BANDO DESIGN LTD. [NEW BUILDING]

PURBA NARSINGHAPUR, EARPUR UNION PARISHAD ROAD, ASHULIA, SAVAR, DHAKA-1349
(23.560502N, 90.181293E)

20th November 2017

Provided Column Layout

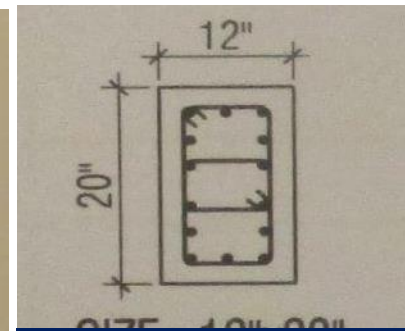
C-2 column size shown 300mm x 500mm in provided drawing

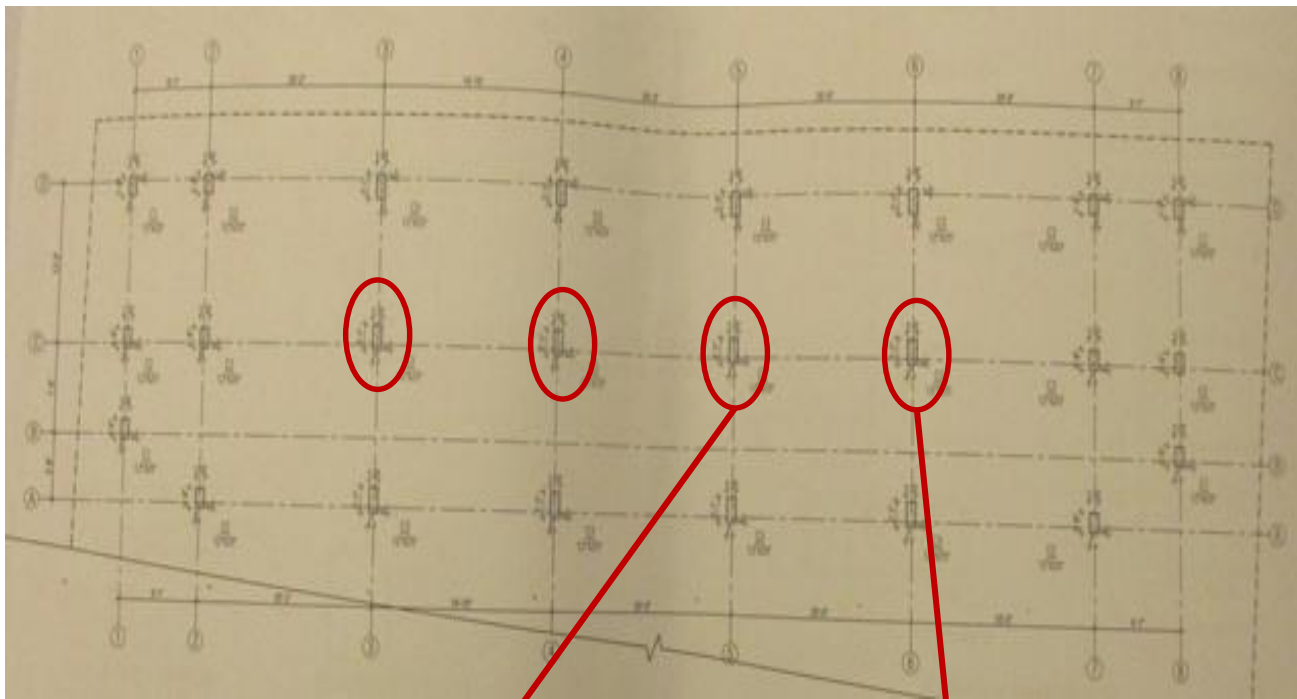
Marked Columns size found 300mm x 680mm which are denoted as C2 (300mm x 500mm) type column in column layout

Marked column size in long direction was measured 680mm

Provided Column Layout

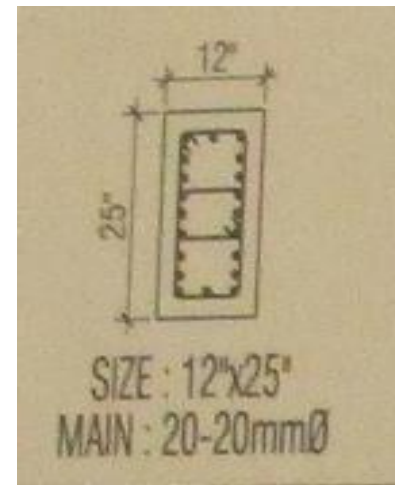
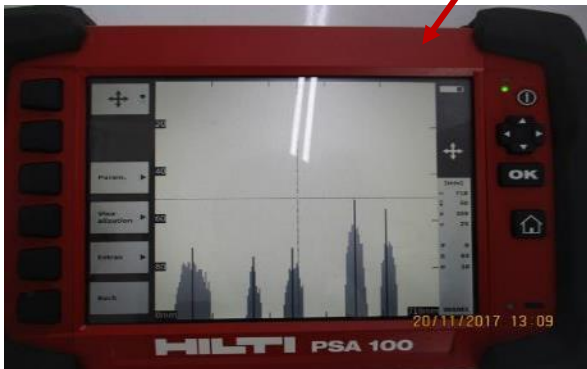
9 nos. rebar were shown on long direction of C3 column in ground floor

Ferro Scanning Image of marked column

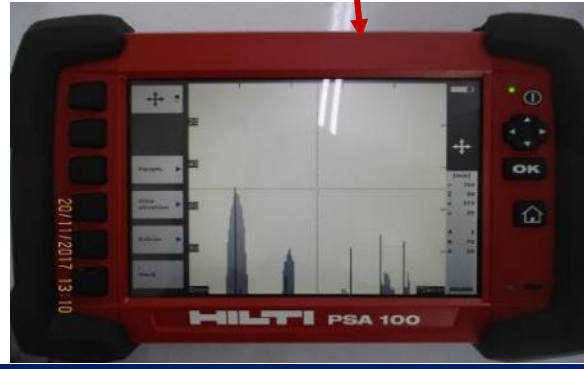
5 Nos of reinforcement found in long direction of C3 type columns at ground floor and 1st floor. But in column schedule, 9 nos of rebar shown for same direction of C3 type column.

Typical slab layout

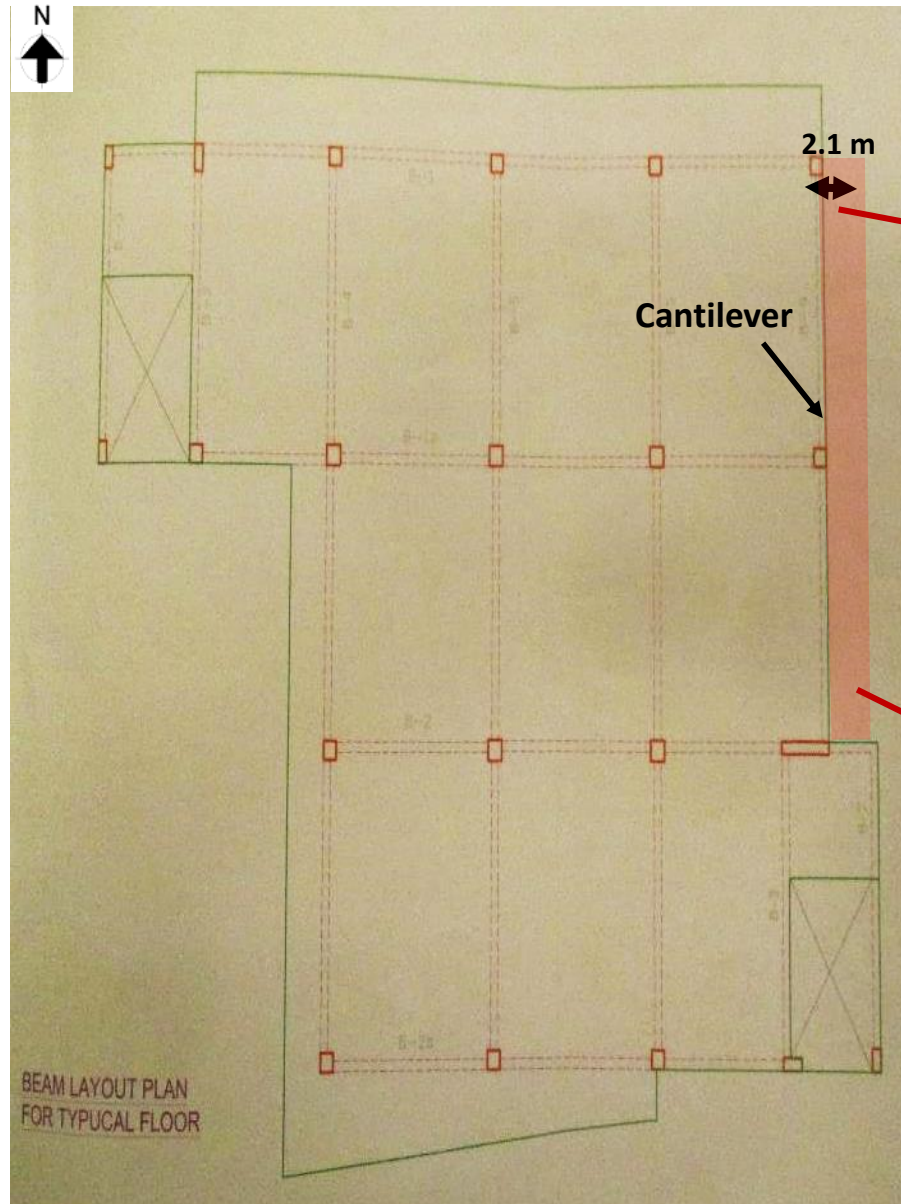
2.1m wide cantilever on East side which was not shown in drawing

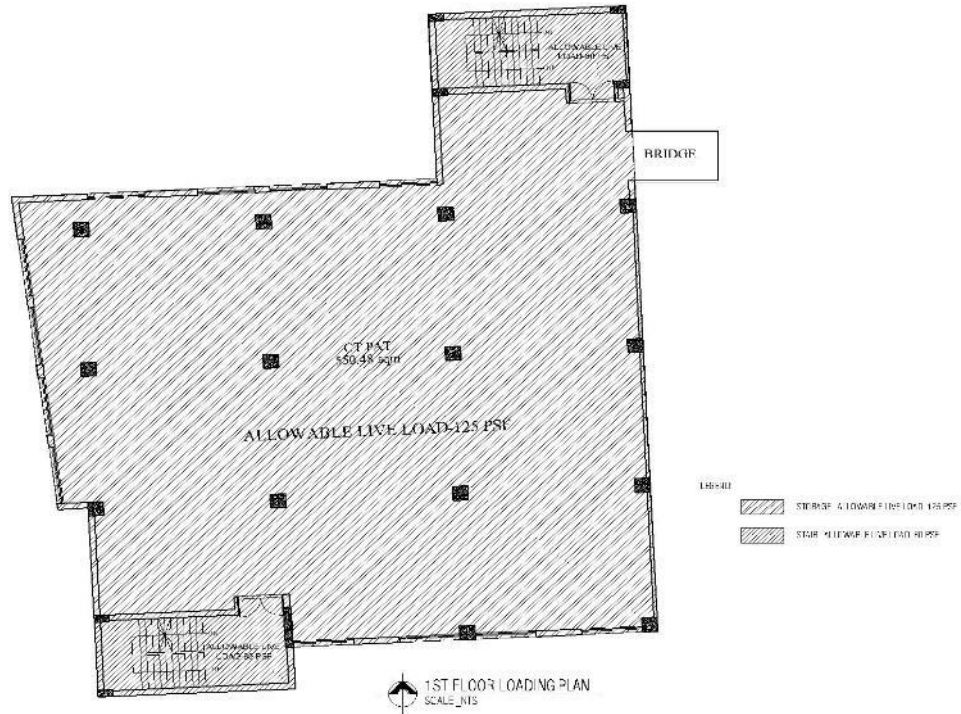
Prepared load plan required to be verified

Factory engineer prepared a load plan considering 6 kPa allowable floor loading. Design review required if the factory management wants to implement the load plan.

During inspection overloading was observed above 5 kPa and FOS calculation for internal column was found satisfactory considering 3kPa allowable floor live loading.

Factory is required to maintain the floor live load 3 kPa until further verification by design engineer.
